RE: Response to Department of Planning and Environment Request for Response to Submissions (SSD 8019 MOD 1) at 21 Honeysuckle Drive, Newcastle 2300

Our Ref: 18307

Figure 2 – Extract from updated flood report showing PMF levels.

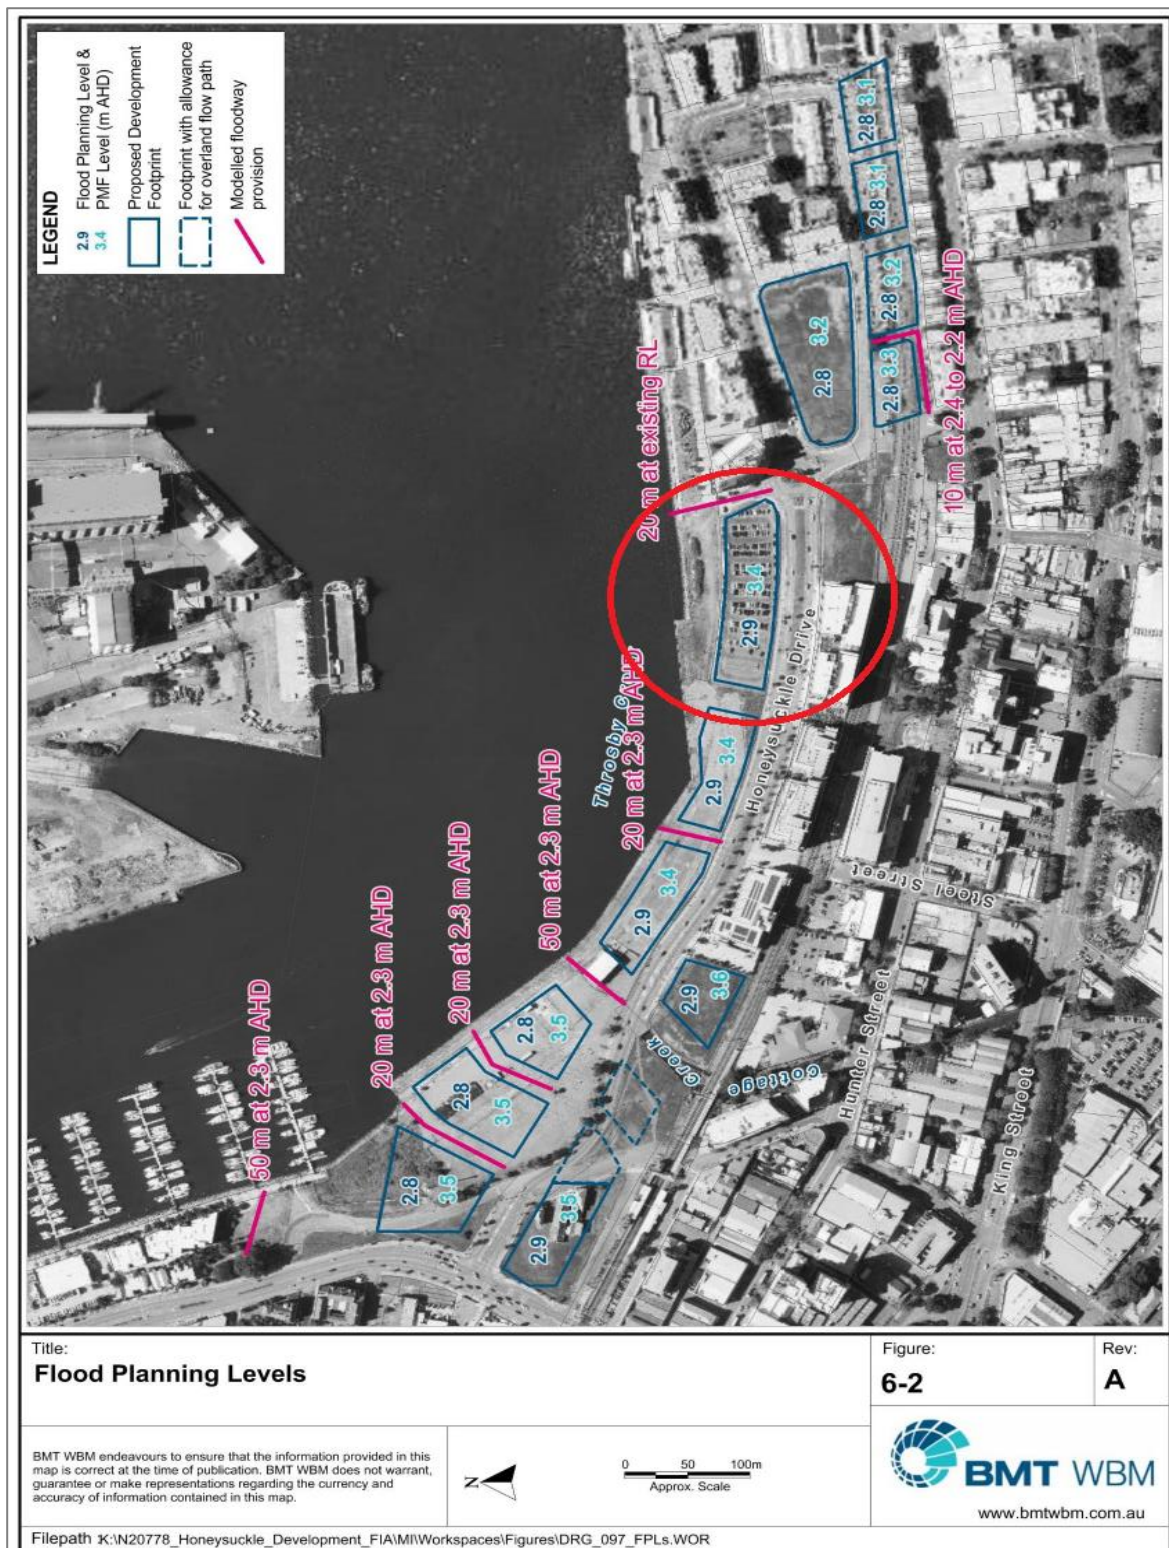
- The Hunter and Central Coast Development Corporation (HCCDC) has advised the Department that there has been an updated flood report for the area that recommends the PMF for the site to be 3.5m (not 3.4m as proposed). Please consider the updated flood study and amended the PMF level accordingly.*
- We note that as per the Modification Application, the proposed modified condition B23 doesn't include any change to the following sentence:
'Openings such as exhaust ducts, car park air intake, vents and the like that could potentially allow for flood waters to enter the basement (except for carpark and access) are to be designed at minimum RL 3.65m AHO'*

Please confirm that no change to the 3.65m level is proposed here.

- The PMF level has been taken from the Honeysuckle Redevelopment Area Flood Study – March 2018 (current document on Newcastle Councils website), which nominates 3.40m as the PMF level. This level has also been reflected in the Flood Emergency Response plan. An extract from the flood report showing the PMF levels is below in Figure 2.
- Point 3 of Councils Flood Management DCP 4.01.3 – Management of risk to property reads as follows:

This level is typically taken as the PMF which should be 3.40m and not 3.65m, as per the updated flood report PMF level, which is shown in Figure 2 below.
